## DEVELOPMENT APPLICATION ASSESSMENT REPORT

<b>Application Number:</b>	DA2025/0847
----------------------------	-------------

<b>Responsible Officer:</b>	Anais Sarkissian
<b>Land to be developed (Address):</b>	Lot 20 DP 239260, 46 Cooyong Road TERREY HILLS NSW 2084
<b>Proposed Development:</b>	Alterations and additions to a dwelling house
<b>Zoning:</b>	Warringah LEP2011 - Land zoned R2 Low Density Residential
<b>Development Permissible:</b>	Yes
<b>Existing Use Rights:</b>	No
<b>Consent Authority:</b>	Northern Beaches Council
<b>Land and Environment Court Action:</b>	No
<b>Applicant:</b>	Skender Cameron Paula Tania Cameron

**Figure 1: Proposed carport**

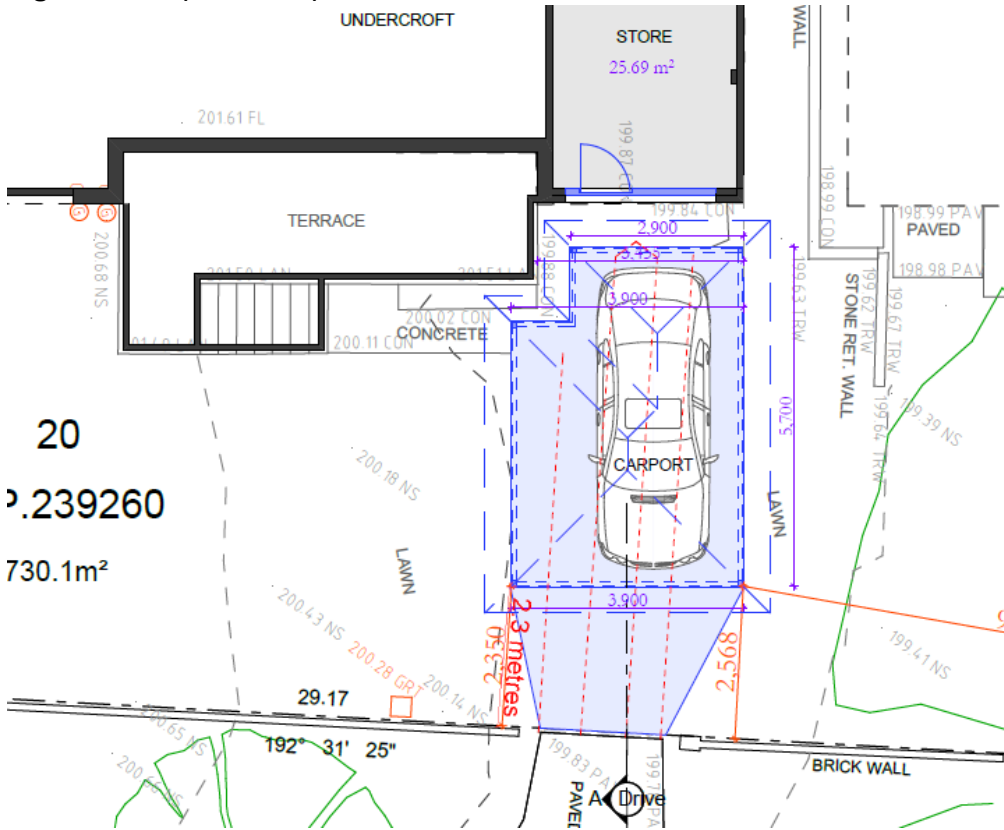
The primary street frontage of the site is to Tiarri Avenue to the east. The proposed carport sits 2.3m from the front boundary at the primary frontage, representing a variation of 64.6% (4.2m) to the minimum standard.

It is important to note that the proposed carport is of minimum length at 5.7m and therefore does not protrude unnecessarily towards the front boundary (refer Figure 1). The carport has been sited as far back from the front boundary as possible, with respect to the shape of the lot and position of the existing dwelling. Furthermore, there are other carports within the front setback area along Tiarri Avenue, such as at #58, which includes a double carport with a setback of between 1.5m and 1.7m from the front

boundary. A garage is also located at #54, which has a front setback of approximately 2.5m. The property directly opposite the subject site at 44 Cooyong Road also has a parking structure erected close to the front boundary.

The proposed parking structure takes the form of a carport, rather than a garage, and therefore maintains a sense of openness at the streetscape.

The proposed carport is not inconsistent with other development along the streetscape, and thereby maintains the visual continuity and pattern of buildings and landscape elements.

The proposed carport will not detract from the visual quality of the streetscape.
